Access Compliance Report Public Rights-of-Way (Pedestrian Signals)

Main Street: **ROSSMOOR_WAY** Cross Street: **LOS_ALAMITOS_BVD** Location: **SE**

ADA ID: **SGRK211217130436** Signal Type: **One Push Button-Non APS** Overall Compliance: **No** Severity Scores: **BTN 1: 10** **BTN 2: N/A** **No BTN: N/A**

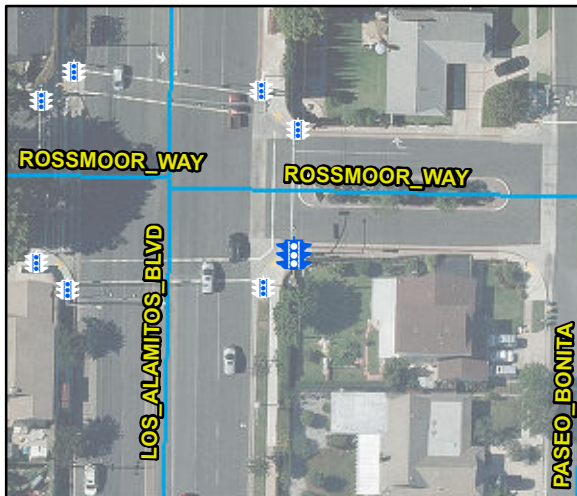
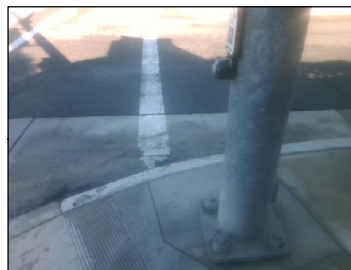
OC Std/PROW: **MUTCD 4e.08**

Possible Solutions: Replace Signal Push Button With APS Button.
